Access Compliance Report Public Rights-of-Way (Pedestrian Signals)

Main Street: **YORBA_ST** Cross Street: **FAIRHAVEN_AVE** Location: **SW**

ADA ID: **SGRK220126122910** Signal Type: **One Push Button-Non APS** Overall Compliance: **No** Severity Scores: **BTN 1: 55** **BTN 2: N/A** **No BTN: N/A**

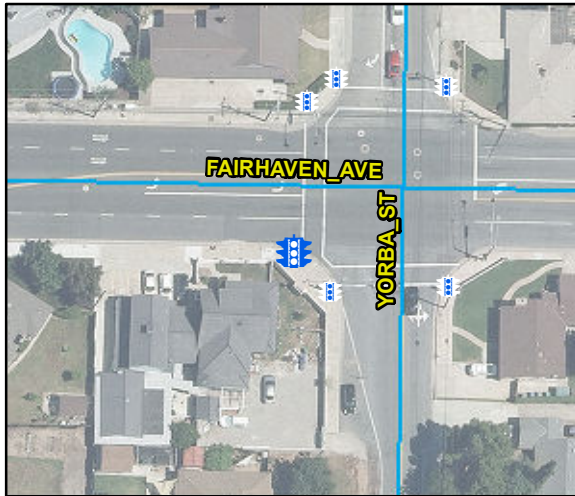
Possible Solutions: Replace Signal Push Button With APS Button. Adjust Signal Button Height. Remove and Replace Clear Space.

OC Std/PROW: R404.2, R404.3, R406, MUTCD 4e.08
